ABINGTON TOWNSHIP

BOARD OF COMMISSIONERS REGULAR PUBLIC MEETING

**RE: Executive Summary for LD-25-01 – 1526 Fairview Avenue
PARID: 30-00-18860-00-1/ TMID: 30196 017
Preliminary/Final Major Subdivision & Land Development Plans Review (2nd Submission)**

LD-25-01 PRELIMINARY/FINAL MAJOR LAND DEVELOPMENT PLANS

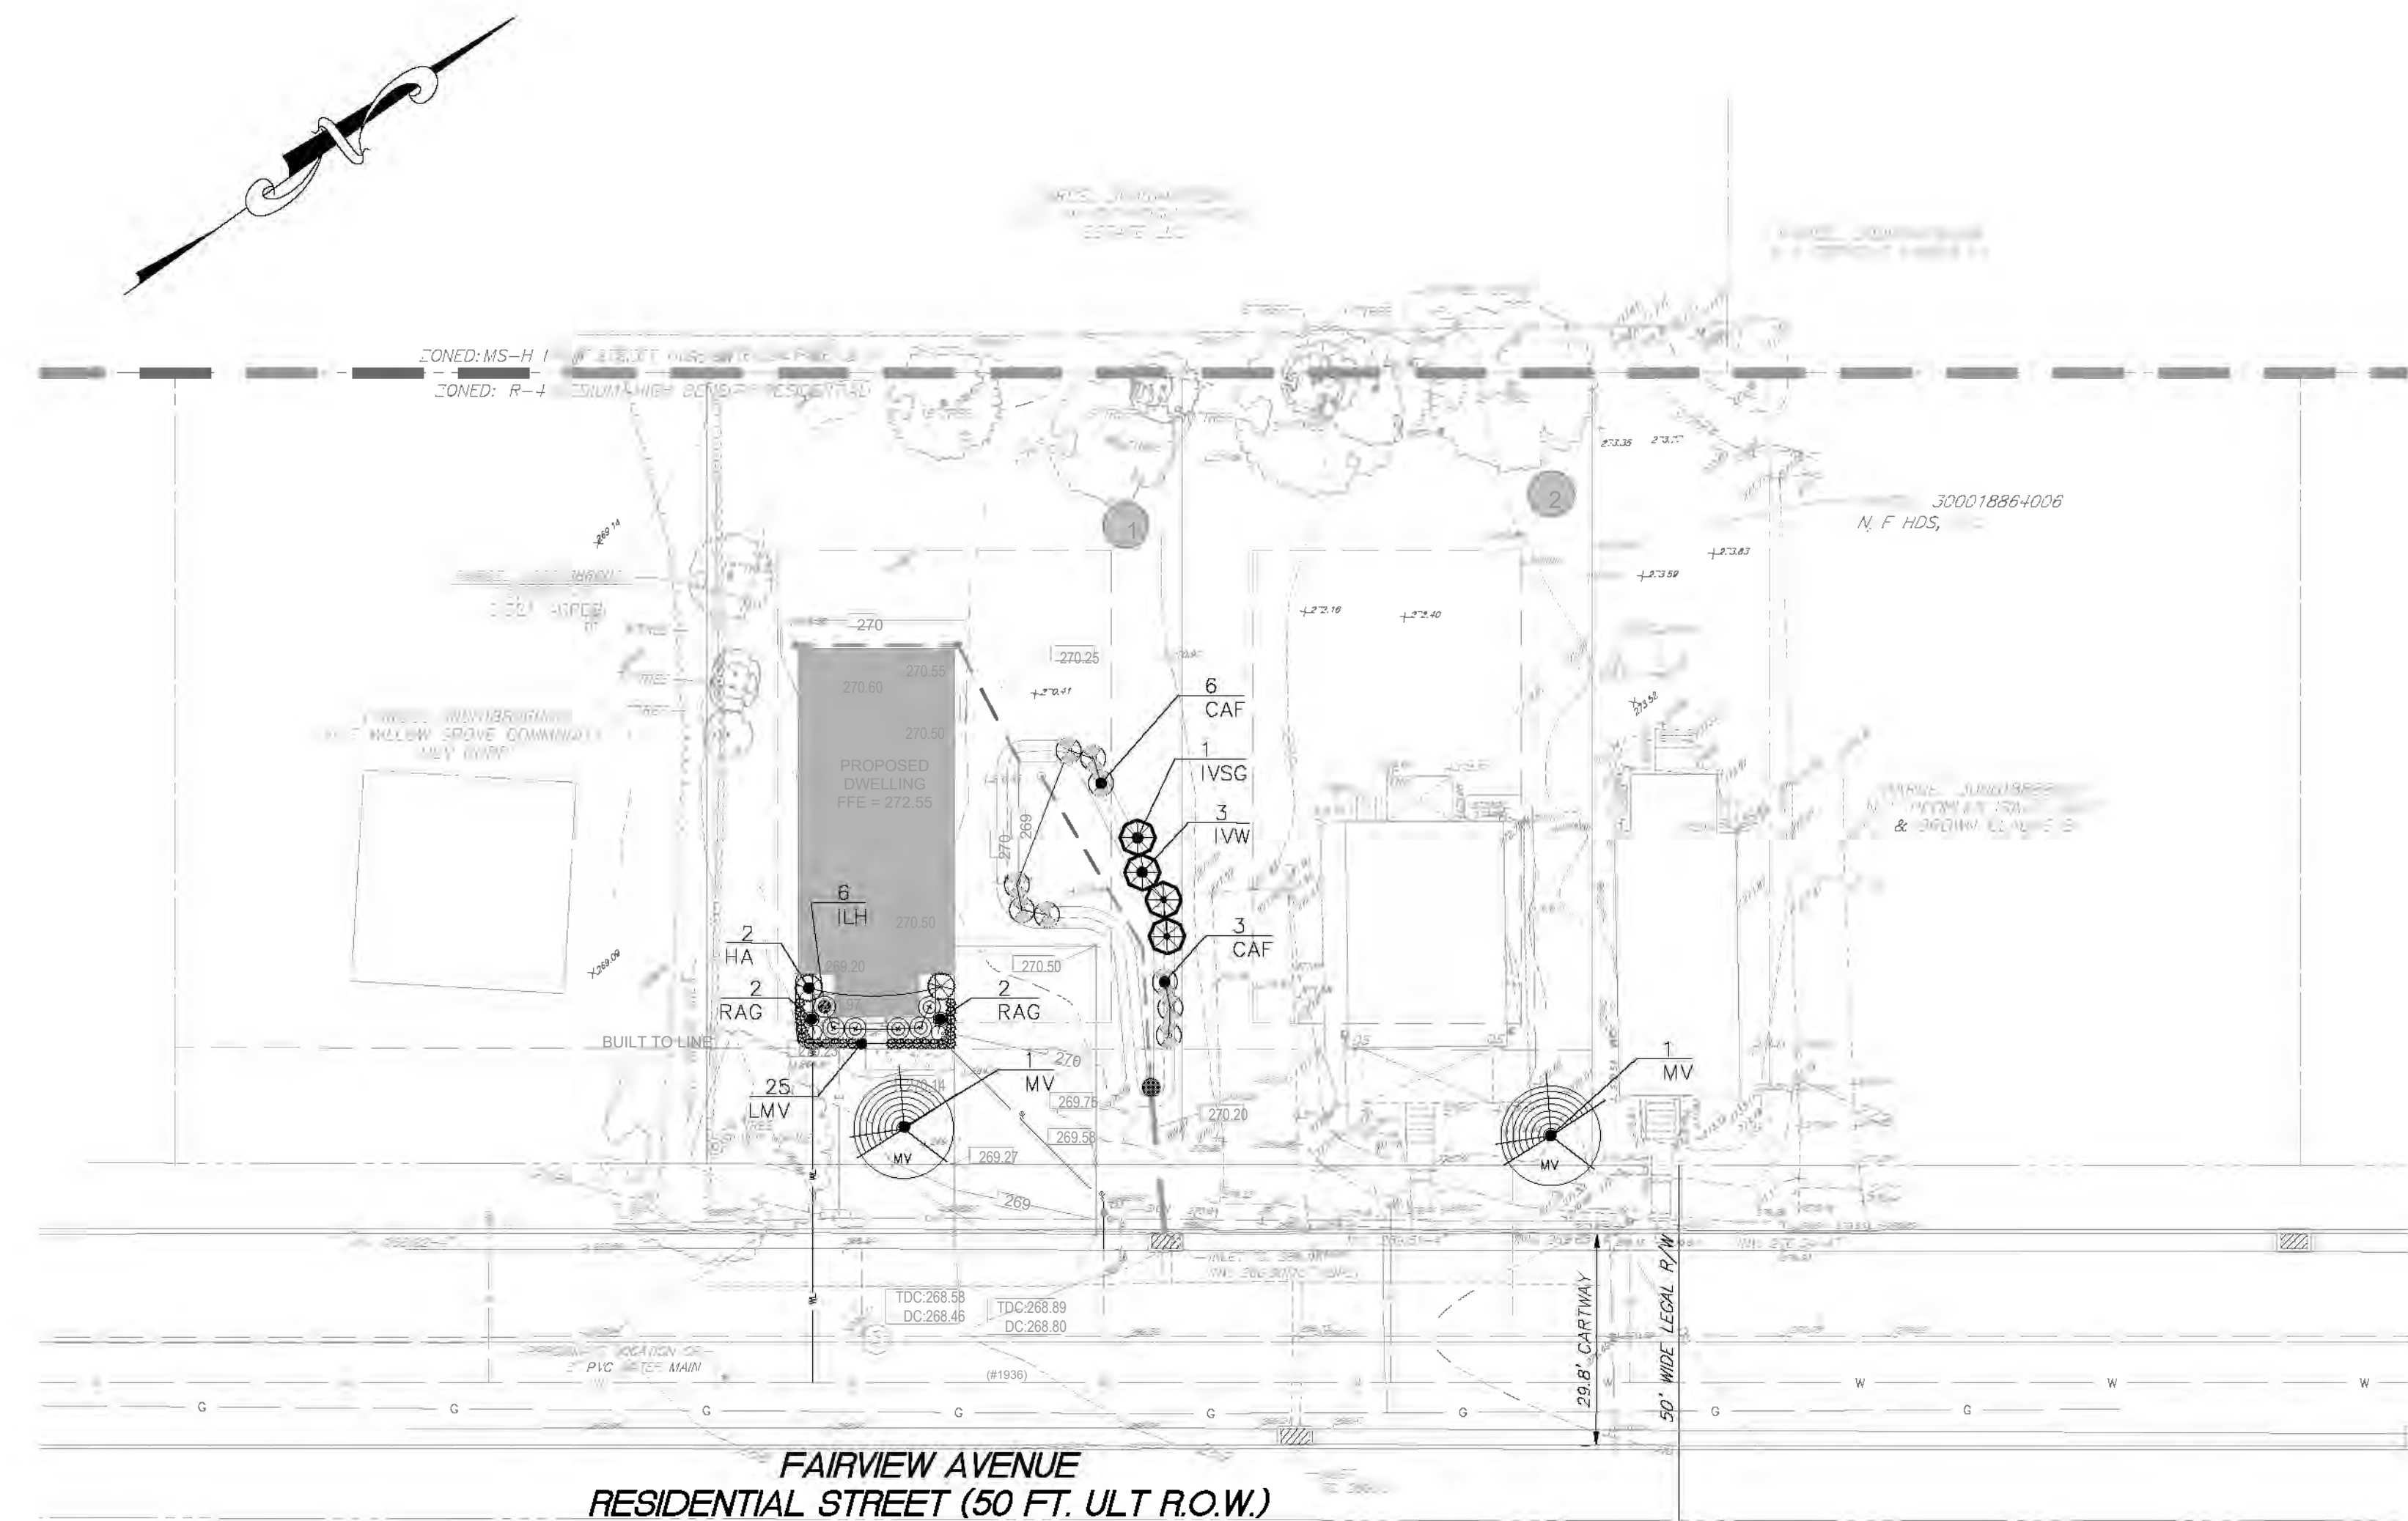
The Landscape Plan (Sheet 9) shall be prepared by a registered landscape architect. The signature and seal of that registered landscape architect shall be provided on the plans.

The Landscape Plan (Sheet 9) shall be prepared by a registered landscape architect. The signature and seal of that registered landscape architect shall be provided on the plans.

Township of Abington
STANDARD DETAIL - SEWER SYSTEM
TYPICAL BUILDING SEWER CLEANOUT ASSEMBLY

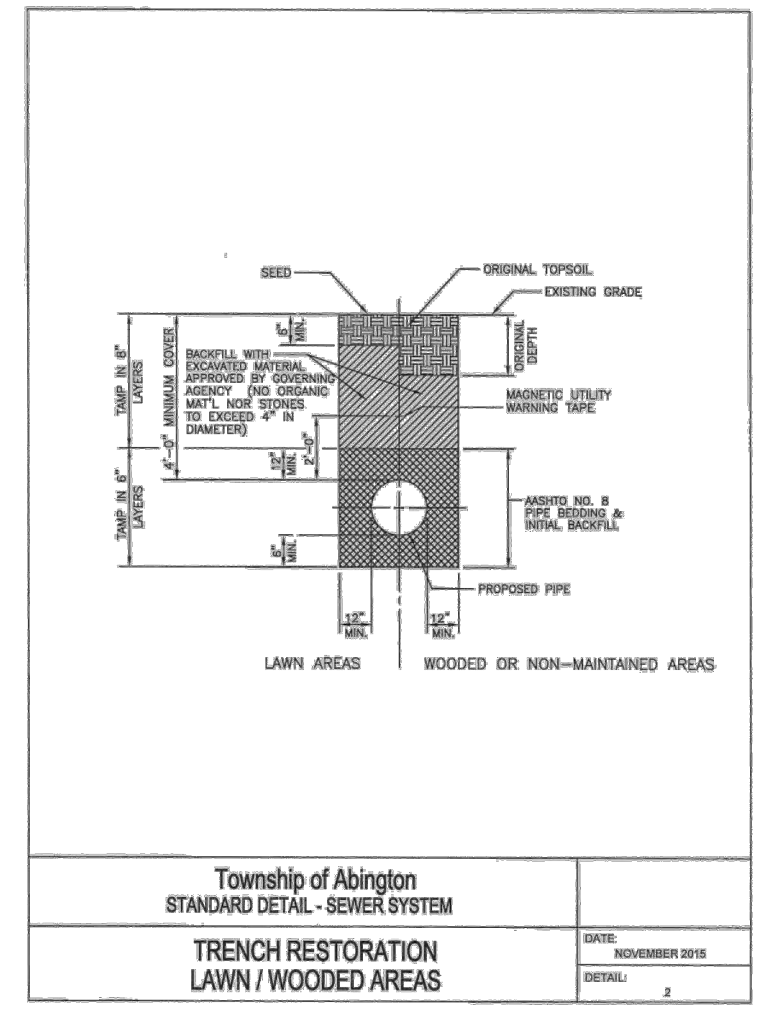
- Sanitary Sewer:
 - Plan is indicating two cleanout fittings on the two 45 degree elbows. A cleanout should not be located at the same point int the sewer line as any other fitting. Thers is only the need for one cleanout fitting, which should be located in the grass area adjacent to the driveway apron.

- The "Typical Cleanout Detail (Paved Areas)" and the "Typical Cleanout Detail (landscape Areas)" should be removed from the plans and replaced with the Township of Abington Typical Building Sewer Cleanout Assembly which utilizes a 2-way cleanout tee fitting. The proposed cleanout adjacent to the driveway apron should also be protected by a cleanout frame and cover assembly which should be added to the Construction Details Sheet. Also, the Township of Abington Trench Restoration Lawn/Wooded Areas should be added to the Construction Details Sheet.

OUTLET CONTROL STRUCTURE
NOT TO SCALE

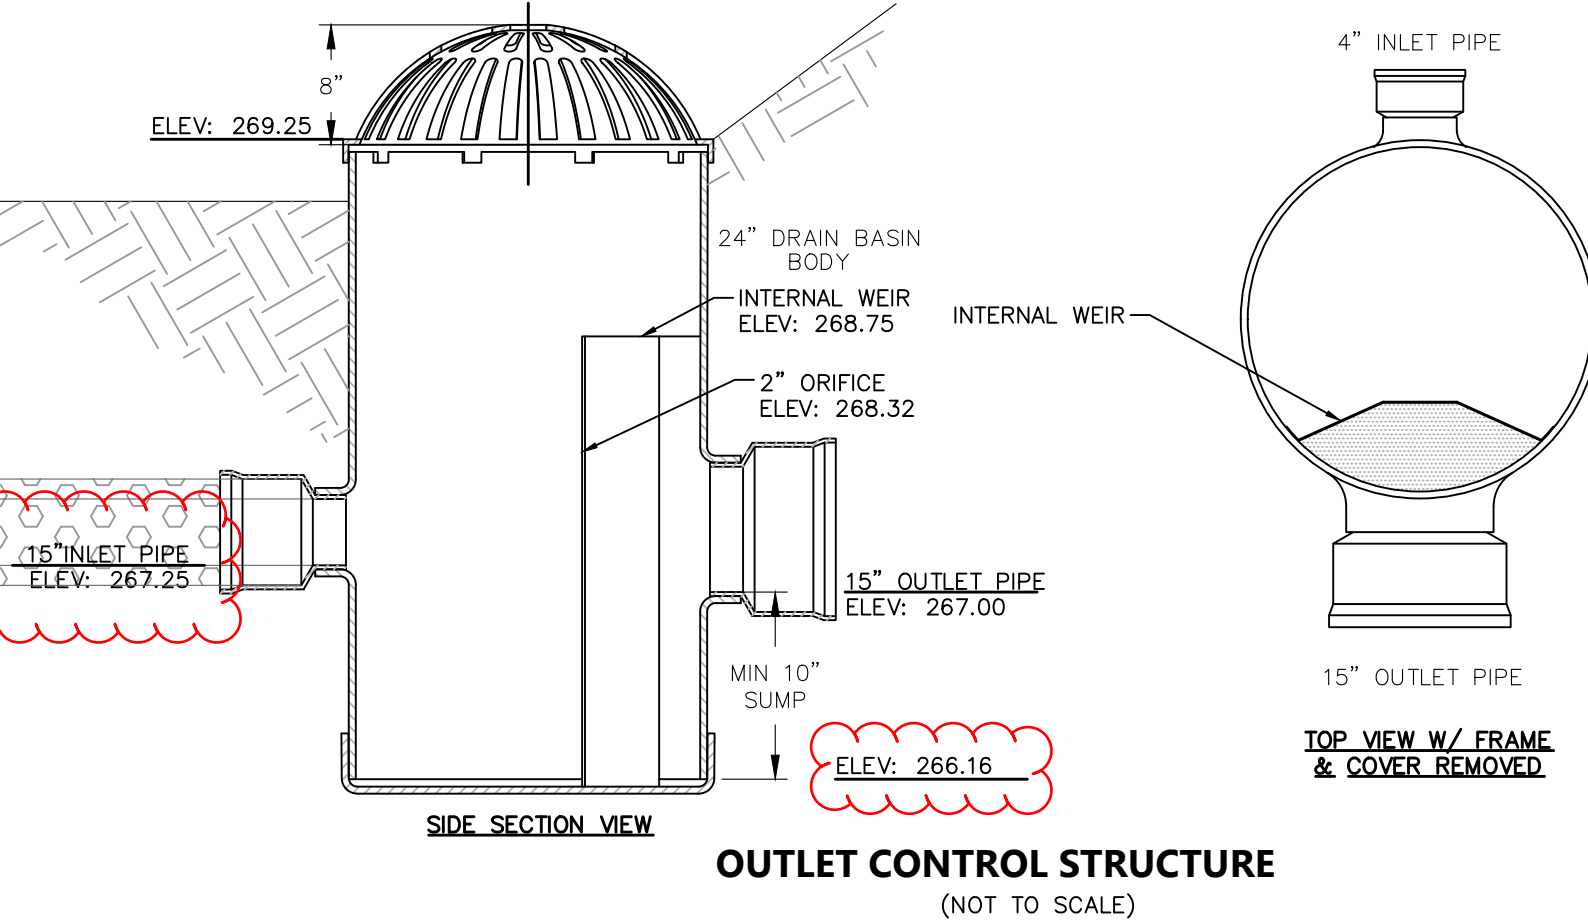
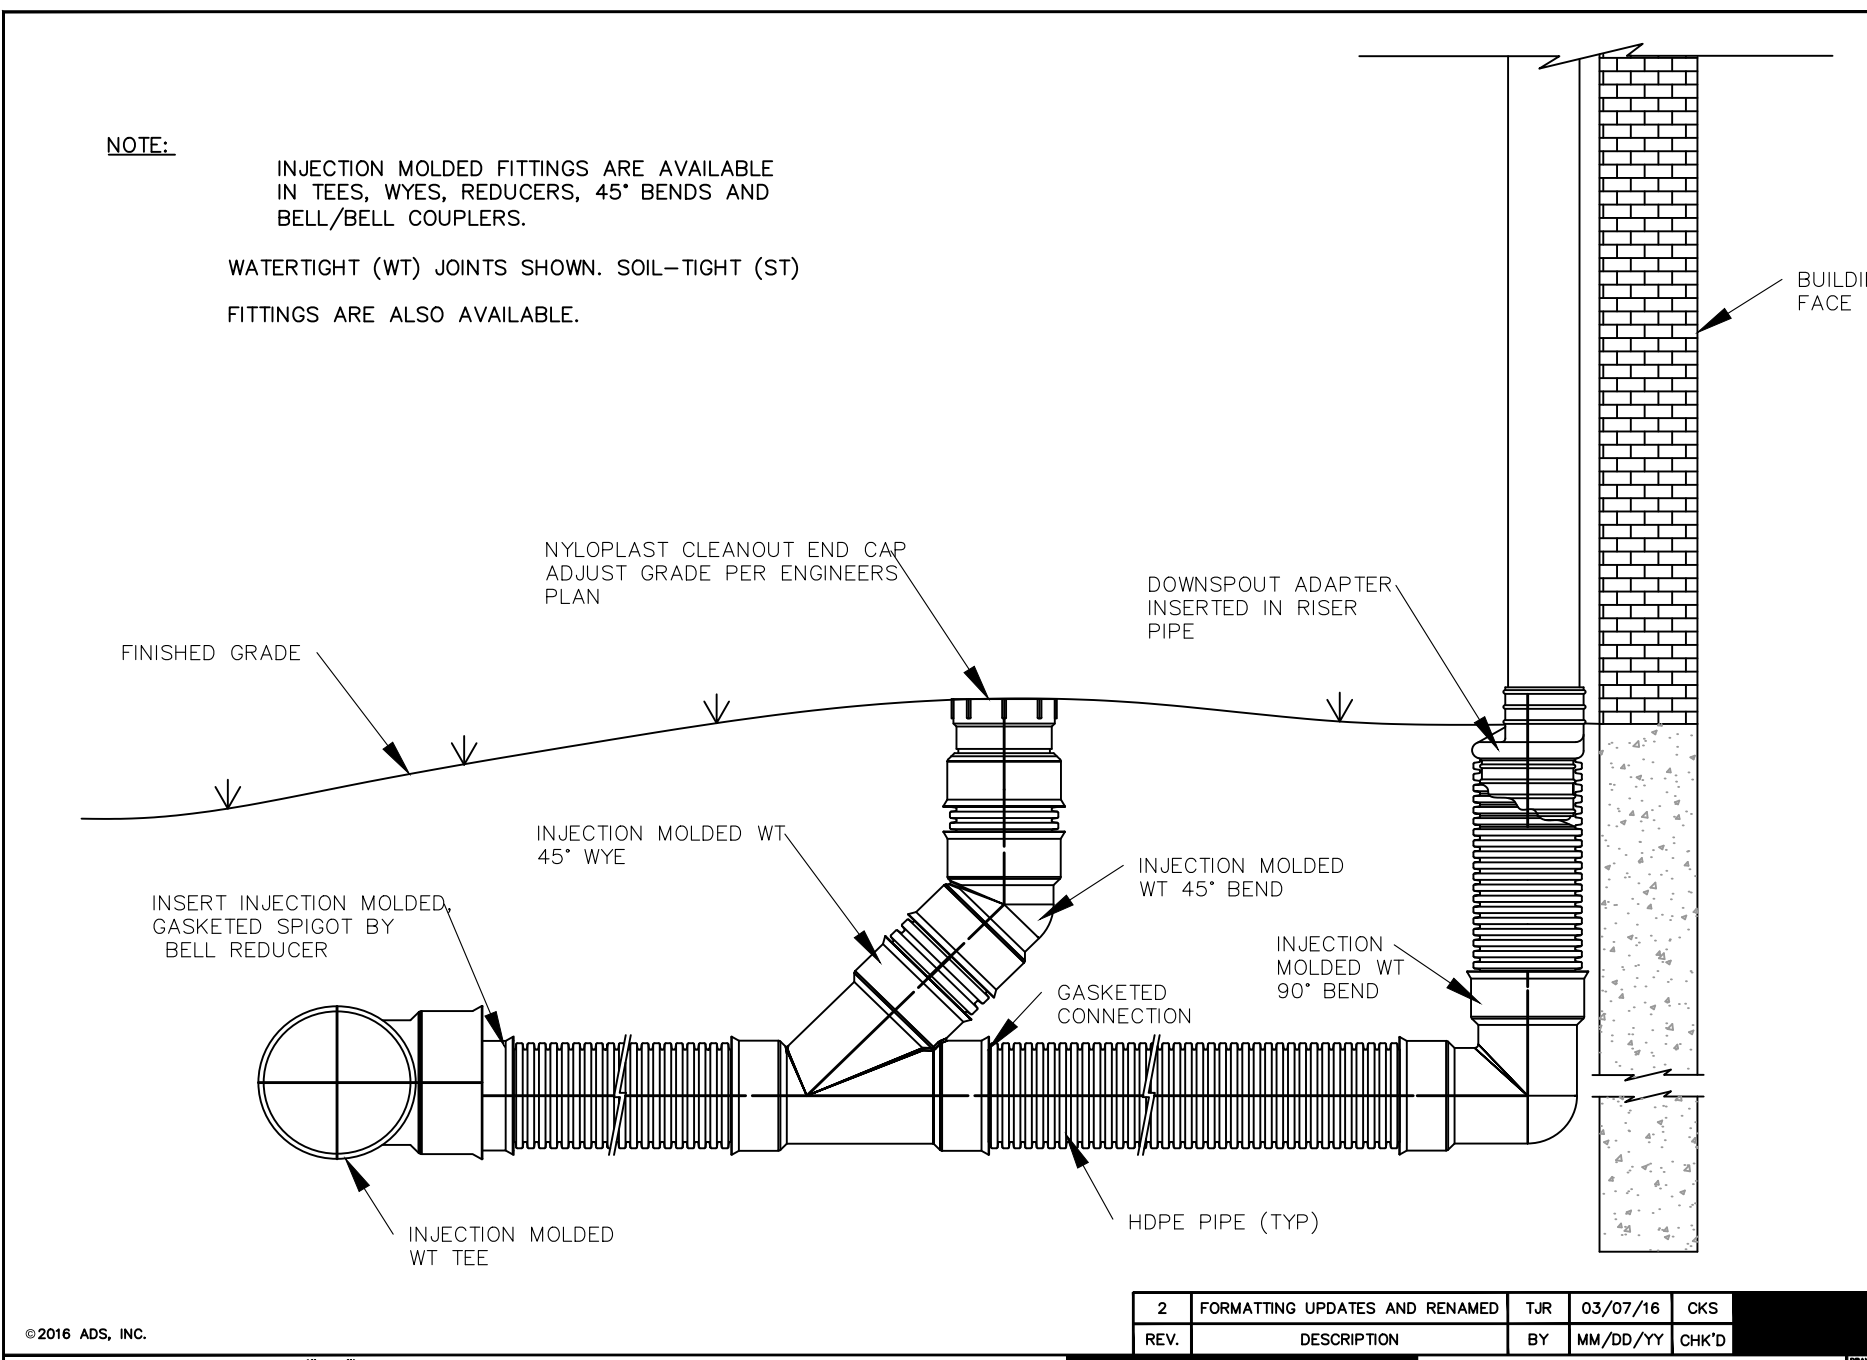
- Add flow dissipator or rip-rap apron for the downspout discharge pipe into the raingarden.
 - On the Outlet Control Structure Detail provided on the plans, the inlet pipe is labeled as 15"; however, on the plans, the inlet pipe is a 4" perforated pipe. The detail shall be revised accordingly.

2 H-7 INFILL DEVELOPMENT HEIGHT REQUIREMENT

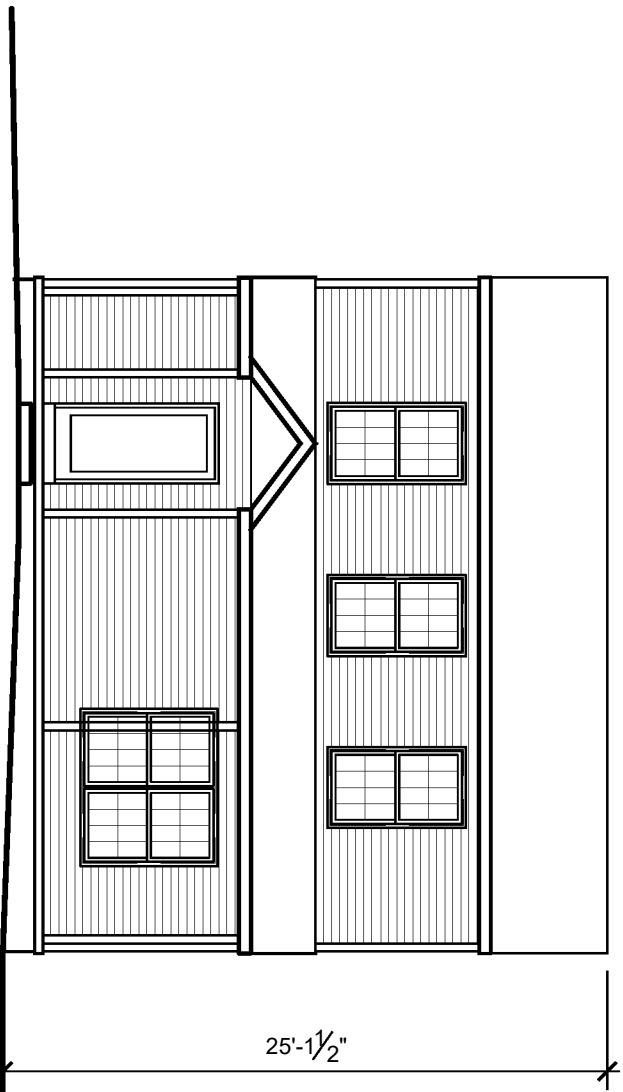
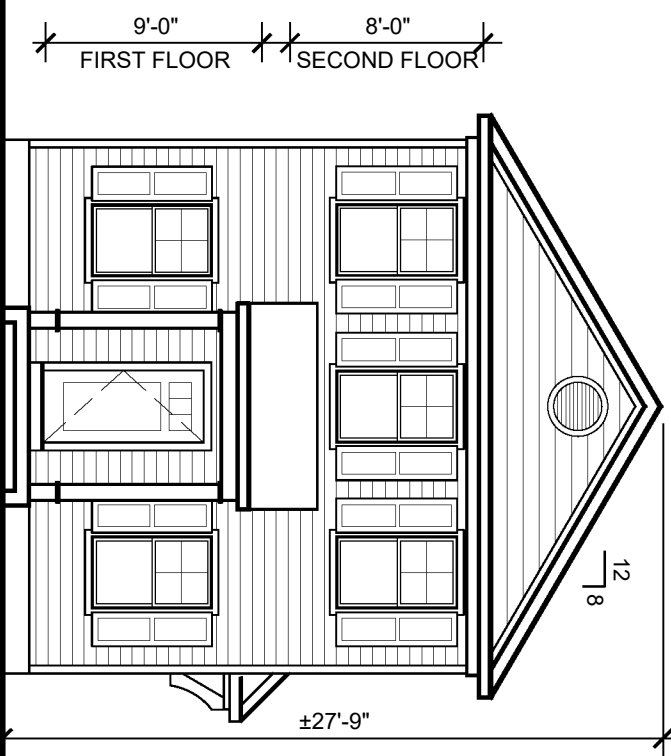
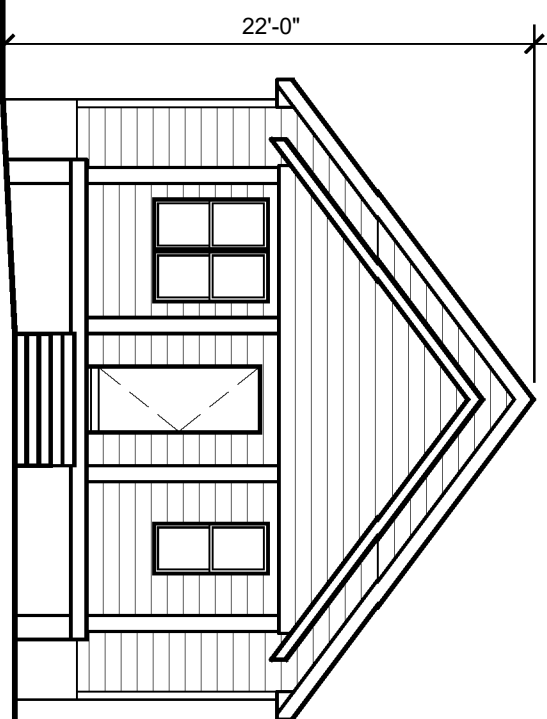
Based on our measurements of the Architectural Plans provided, the height and length of the proposed dwellings will be approximately 24 feet high and 52 feet long, respectively, which complies with the building height and length requirements. The Applicant shall revise the Zoning Data Table on the Site Plan (Sheet 1) to show the actual proposed building height and length to clarify and ensure compliance with this Code Section.

- Per 2103.H Use H-7.4.c.(2)– Infill Development** – The build-to-line of the new home must be equal to the average of the front yards of the two reference houses (the build-to-line for the new home may be adjusted up to 5 feet from the average to provide some flexibility).
